Access Compliance Report

Public Rights-of-Way

(Curb Ramps)

Intersection ID: 51750	Main Street: GOLF_LINKS_DR_N	Cross Street: ALLISON_WOODS_DR	Location: SE
ADA ID: 33FB0DD547A3	Ramp Type: Perp	Initial Pass/Fail: Fail	Overall Compliance: No
Severity Score: 37.5			
Codes/Mitigation Info/Possible Solution		Field Measurements/Component Compliance

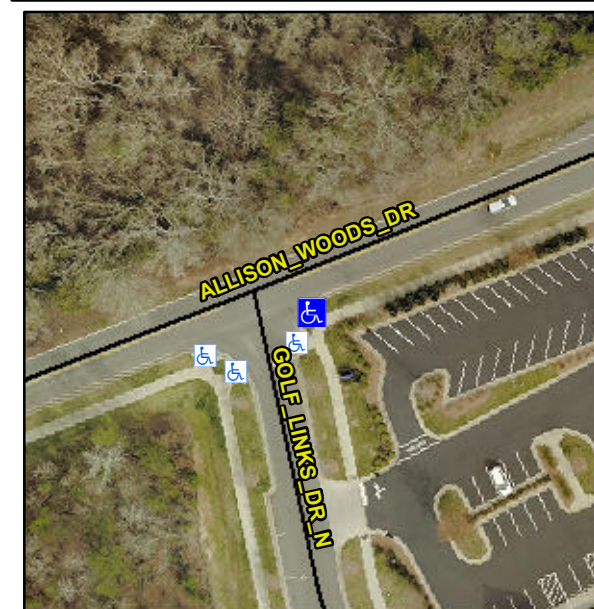
Not Found, R304.2.2, R304.5.3

Compliance	Description	Data	Compliance	Description	Data
N/A	Ramp Length (in)	120.0	No	Ramp Slope (%)	12.2
Yes	Ramp Width (in)	48.0	No	Ramp XSlope (%)	6.2
N/A	Flare Type LT	N/A	N/A	Flare Type RT	N/A
N/A	Flare Slope LT (%)	N/A	N/A	Flare Slope RT (%)	N/A
N/A	Flare Traversable LT?	N/A	N/A	Flare Traversable RT?	N/A
N/A	Landing Length (in)	N/A	N/A	DWS Provided?	N/A
N/A	Landing Width (in)	N/A	N/A	DWS Contrast?	N/A
N/A	Landing Slope (%)	N/A	N/A	DWS Length (in)	N/A
N/A	Landing X Slope (%)	N/A	N/A	DWS Full Width?	N/A
N/A	Landing Curb? (Y/N)	N/A	N/A	DWS Offset (in)	N/A
N/A	Shared Landing?	N/A			
N/A	Gutter Ponding?	N/A	N/A	Gutter Slope (%)	N/A
N/A	Gutter Lip Ht (in)	N/A	N/A	Gutter X Slope (%)	N/A
N/A	Painted X Walk1?	No	N/A	Painted X Walk2?	N/A
	X Walk 1 Direction	To N		X Walk 2 Direction	N/A
N/A	X Walk 1 Width (in)	N/A	N/A	X Walk 2 Width (in)	N/A
	X Walk 1 Slope (%)	3.6		X Walk 2 Slope (%)	N/A
	X Walk 1 X Slope (%)	3.1		X Walk 2 X Slope (%)	N/A

Remove & Replace Entire Ramp.
